FIELD SERVICE BULLETIN

FSB Number: BJCCFSB2006-143
Author: Feng Joanna
Date: Apr 6, 2006
Total No. of Pages: 3
Subject: **V3i Earpiece Distortion in a Call_Diaphragm not Adhered Firmly**
Model Affected: V3i
Level of Repair: 2

Figure 1: The diaphragm/voice coil sub-assembly had come off with the metal lid as the adhesive lid was peeled off for internal visual inspection. A diaphragm not adhered to its seating plane on the bottom housing allowed the diaphragm to flap and cause the distortion.

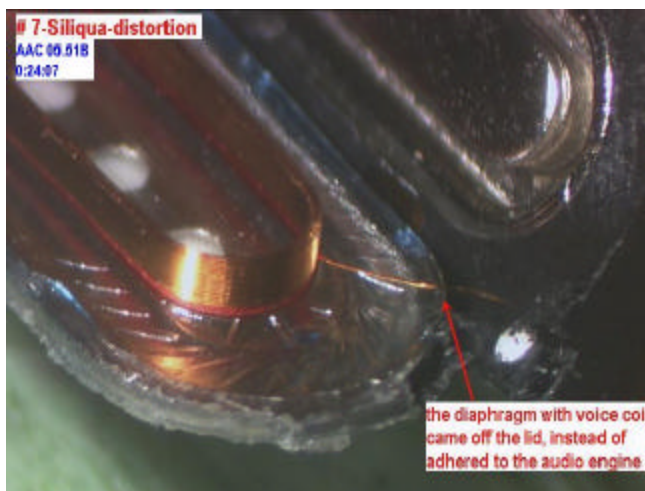
This issue is due to the earpiece diaphragm not adhered to the bottom housing seating plane firmly. The excessive gel was the root cause for the loss of diaphragm adhesion. Due to the gule is too much on the diaphragm during manufacturing, the glue stuck on the housing and accumulated little by little because of diaphragm vibration after several cycle tests or the mobile phone worked for a long time, which made the low sound and distorted sound.

AAC has adjusted the glue pressure from 0.04--0.08mpa to 0.04--0.06mpa to control glue amount, so that they can prevent the glue too much when the glue pressure was close to the upper limit and the scope of glue pressure was too big.
